COUNTY OF ROCKLAND		PAGE: 2
FACILITIES MANAGEMENT		
BLDG. A., 2 nd FLOOR, 50 SANATORIUM RD, POMONA, NY 10970		
PHONE: 845-364-2958 / FAX: 845-364-3810		
CAPITAL PROJECT NUMBER: 1483	BID NUMBER: RFB-RC-2021-1483-001	
PROJECT: CONSTRUCTION OF NEW ANIMAL SHELTER

BID QUESTION FORM

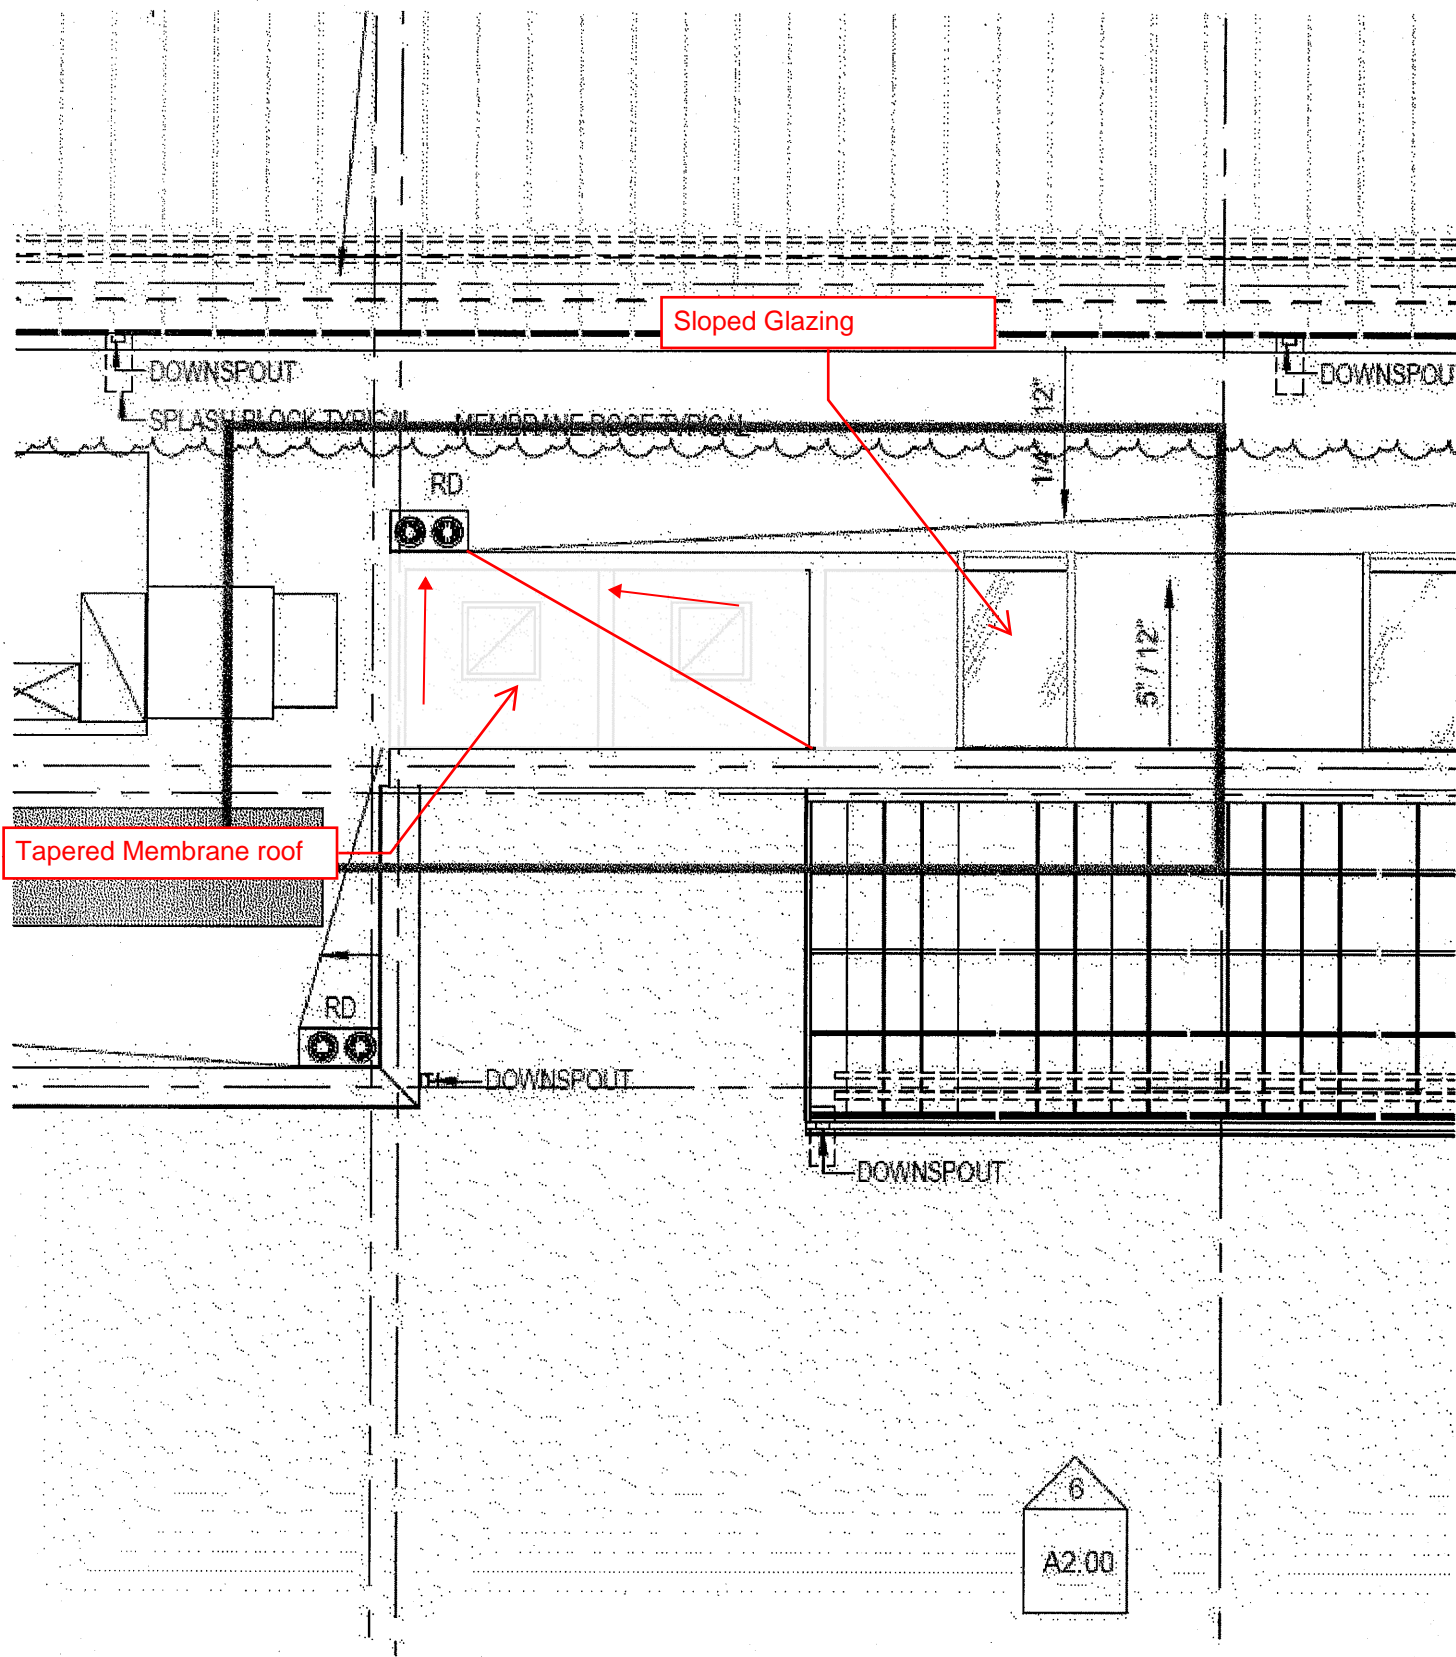
7. Please see the attached image titles "Identify". Please clarify with details or other means what is occurring at the area highlighted in red.
8. 077210 Snow Guards. The specified polycarbonate adhesive attached snow guards will void the metal panel finish warranty. Please advise on an alternative attachment of snow guards.

7. Please see the attached image titled "Identify". Please clarify with details or other means what is occurring at the area highlighted in red.
8. 077210 Snow Guards. The specified polycarbonate adhesive attached snow guards will void the metal panel finish warranty. Please advise on an alternative attachment of snow guards.

7. The portion of roof shown in the attached drawing has a graphic error. See mark up of the attached partial roof plan for clarification.
 8. The product for snow guards as specified in 077210-part 2.2 A 1 is incorrect. Do not use plastic type snow guards. Provide metal snow guards securely fastened to the standing seam. Use Berger AP516 Galvanized snow guards as basis of design.
-

7. The portion of roof shown in the attached drawing has a graphic error. See markup of the attached partial roof plan for clarification.
8. 8. The product for snow guards as specified in 077210-part 2.2 A 1 is incorrect. Do not use plastic type snow guards. Provide metal snow guards securely fastened to the standing seam. Use Berger AP516 Galvanized snow guards as basis of design.

SK-1

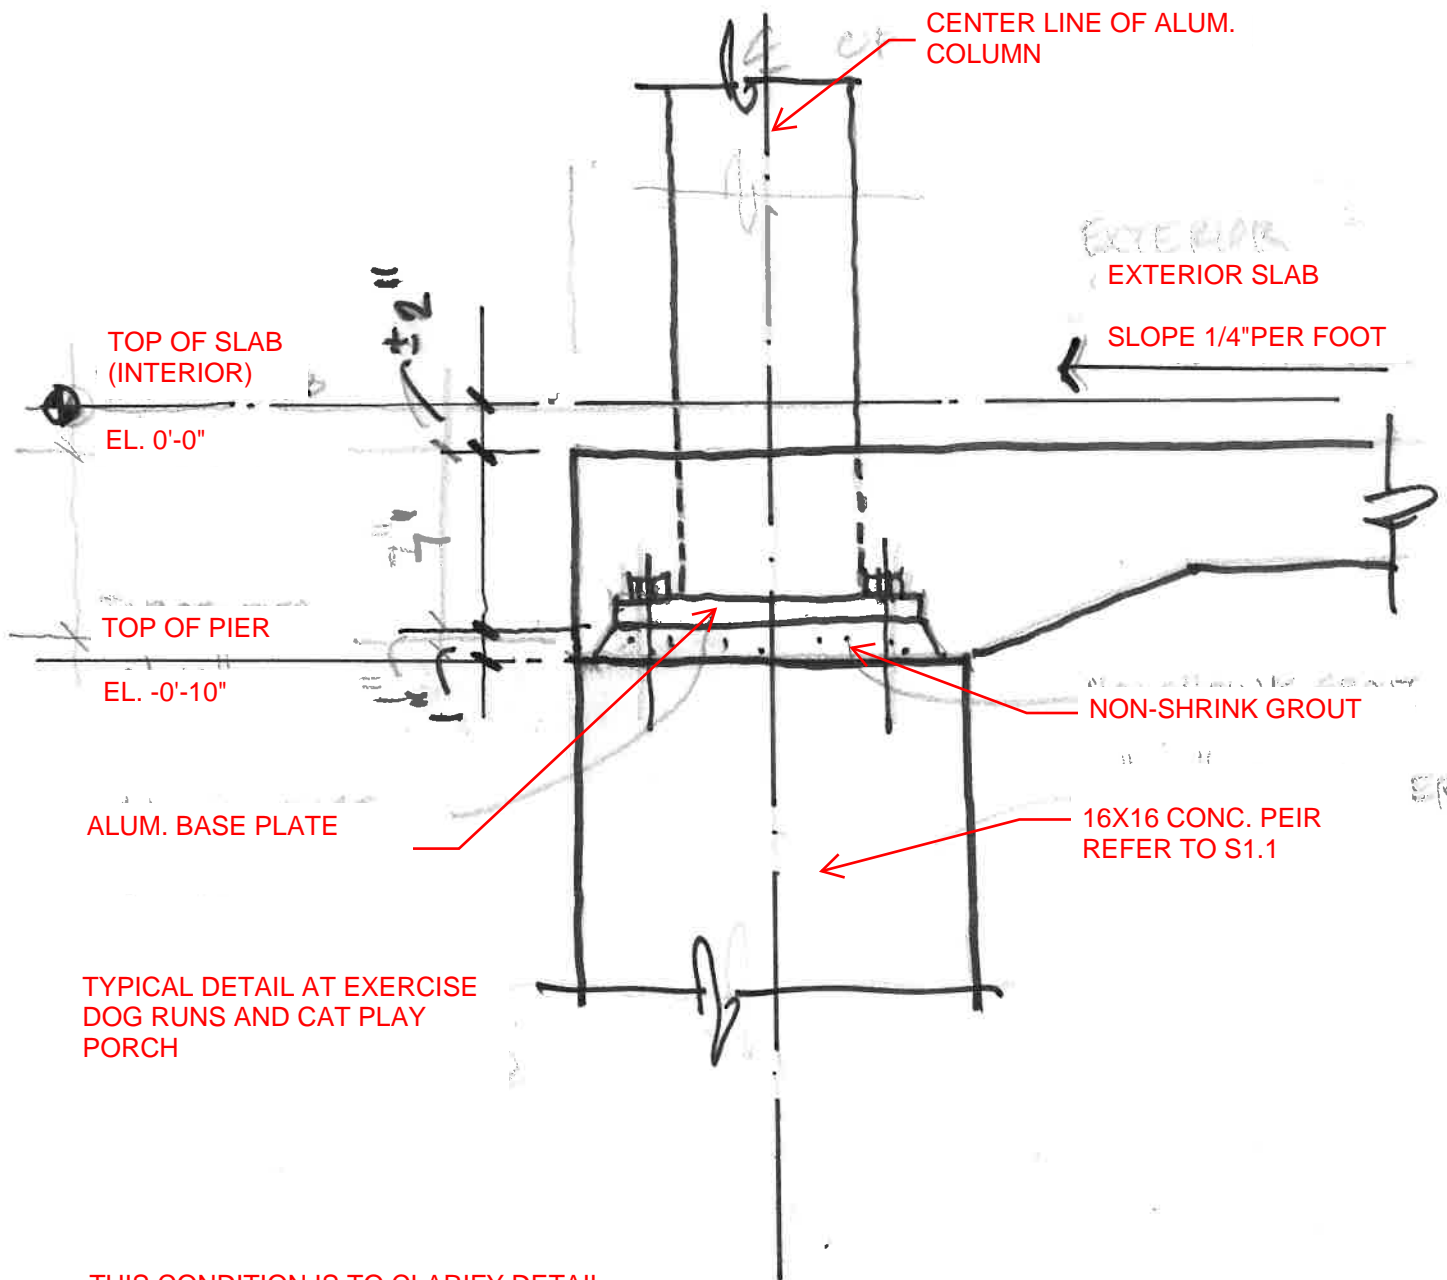
- Question 2: Regarding the piers for the canopy structure. On drawing S1.1 the piers for the canopy labeled (P2) For these same pier locations when viewing Detail 1 on A4.01 and Detail 2 on A4.03 the column pier is shown below grade with no dimension noted. What is the top of pier elevation for the piers relative to the top of slab which is shown at Elevation 100'-0"?

THIS CONDITION IS TO CLARIFY DETAIL
1/A4.01. THE HEIGHT OF PIER IN
RELATION TO CONC. SLAB IS AS SHOWN.
FOR FURTHER INFORMATION SEE S1.1
